Re: 393-419 Commercial Street

Your permit to erect a self-service station (not public), as per plan, at 393-419 Commercial Street is being issued with the following requirements.

Inquiry - 393-419 Commercial Street

Subject: Smilding Permit to Cover Construction of Loading Platform at 407 Commercial St.

Site Plan - V

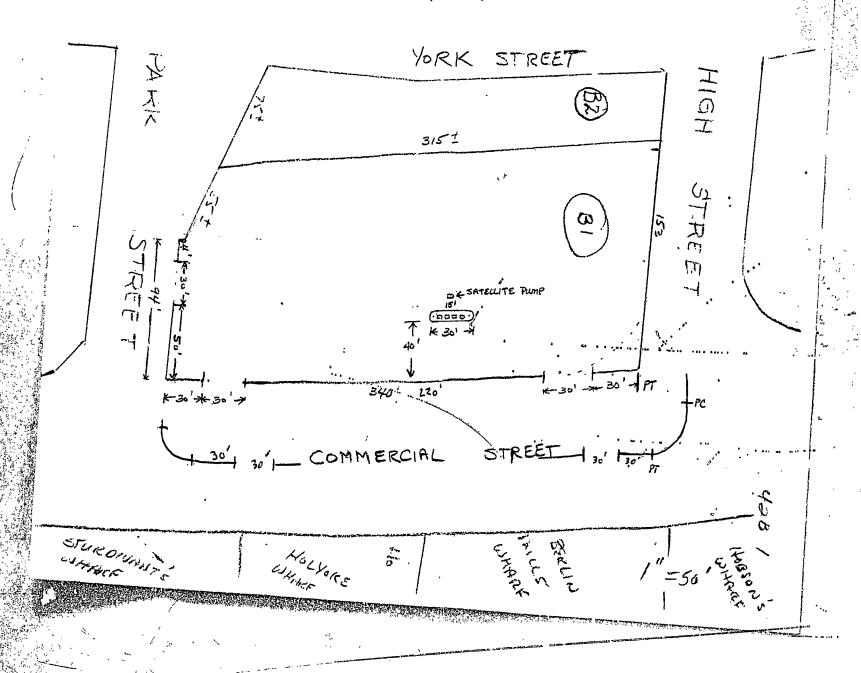
Your permit to erect a self-service station (not public), as per plan, at 393-419 Commercial Street is being issued with the following requirements.

- 1. Fight trees shall be planted (Red Oak or Norway Maple, minimum 3" caliber) along Commercial Street side of property.
- 2. Powerlines shall be underground.
- 3. A grassed berm shall be constructed along the entire Commercial Street frontage, minimum (3) three feet high with shrubs. This provision is conditional upon the traffic engineer approving this concept of defining the entrances.
- 4. Front sign not be rotating.
- Guard rail fence mentioned in Public Works Site Plan Review must be constructed of wood unless otherwise approved by the Planning Div.
